Subject: RATTLE / CHATTER NOISE FROM REAR DIFFERENTIAL	Bulletin No: 03-001/16
	Last Issued: 01/08/2016

- This bulletin supersedes the previous bulletin 03-002/14, issued on 05/13/14. The APPLICABLE MODEL(S)/VINS, DESCRIPTION, REPAIR PROCEDURE, and PART(S) and WARRANTY INFORMATION have been revised.
- Changes are noted below in Red beside the change bar.

2013-2016 CX-5 AWD vehicles with VINs lower than JM3KE*****725078 (produced before October 1, 2015)

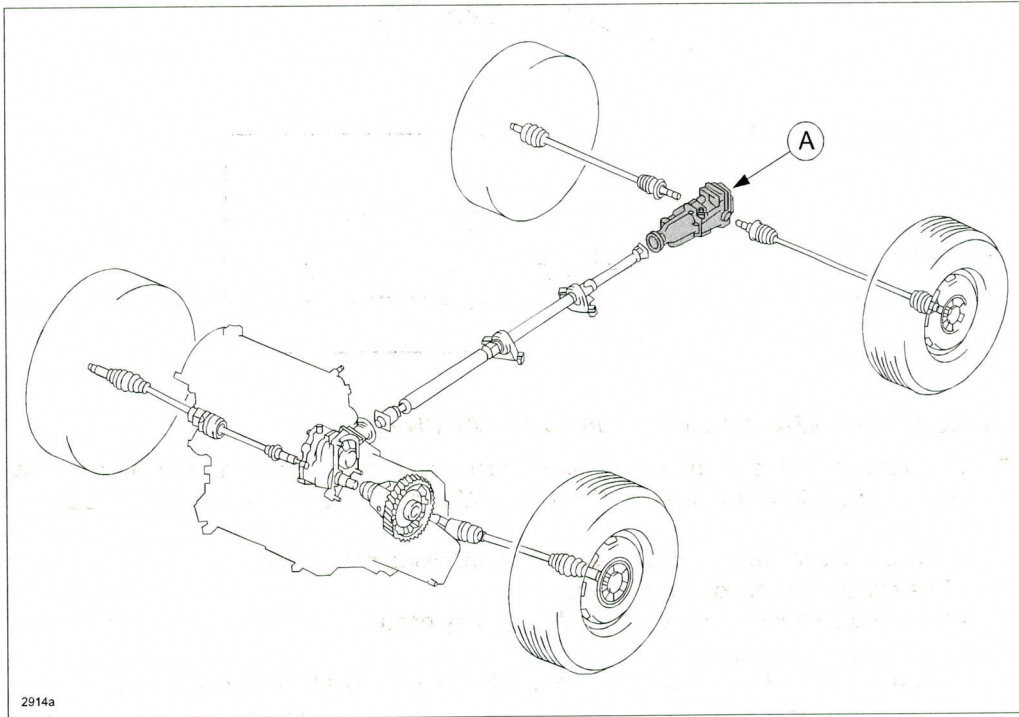
The following mass-production changes have been implemented to eliminate the noise.

Description	Starting VIN and Production Date
1. The assembly process was improved.	JM3KE*****391989 (September 16, 2013)
2. The shape of the coupling unit housing was changed.	JM3KE*****725078 (October 1, 2015)

PARTS INTERCHANGEABILITY:

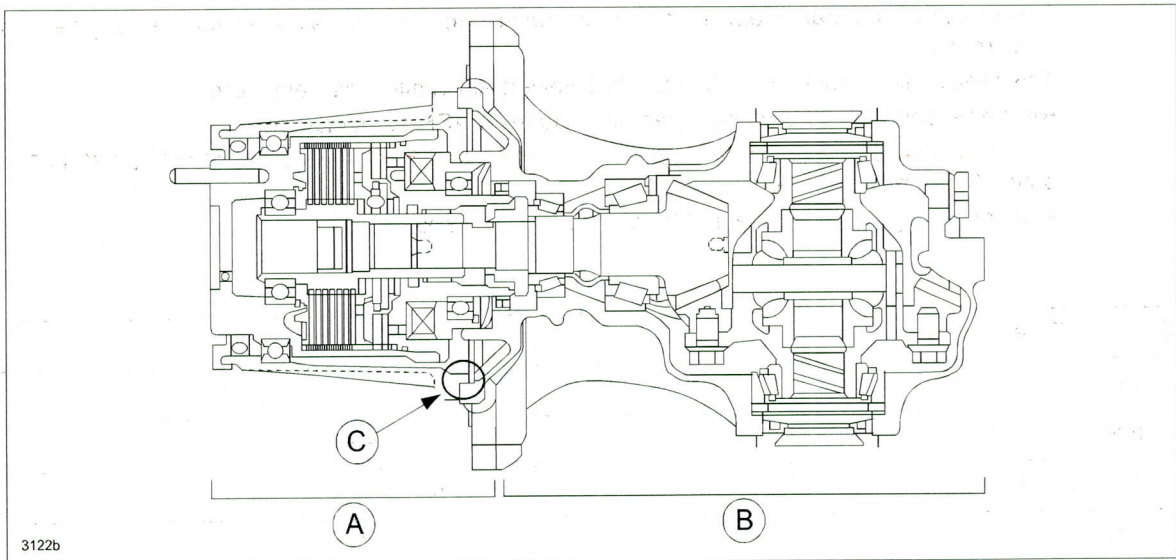
- New coupling unit (A) (KE01-27-97XA) and differential housing (B) are used during mass-production.
- New coupling unit IS NOT INTERCHANGEABLE WITH THE OLD DIFFERENTIAL HOUSING due to an increase in guide (C) length.

IDENTIFY DIFFERENTIAL HOUSING:

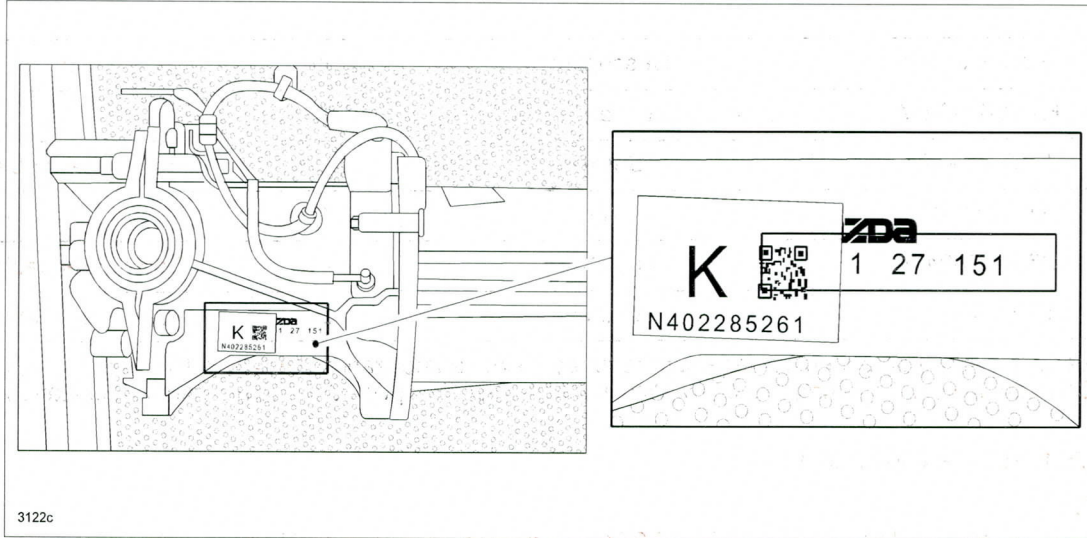
- The **OLD** differential housing has no suffix (KA01-27-151) in the molded part number (as shown below).
- The **NEW** differential housing has an "A" suffix (KA01-27-151A) in the molded part number.
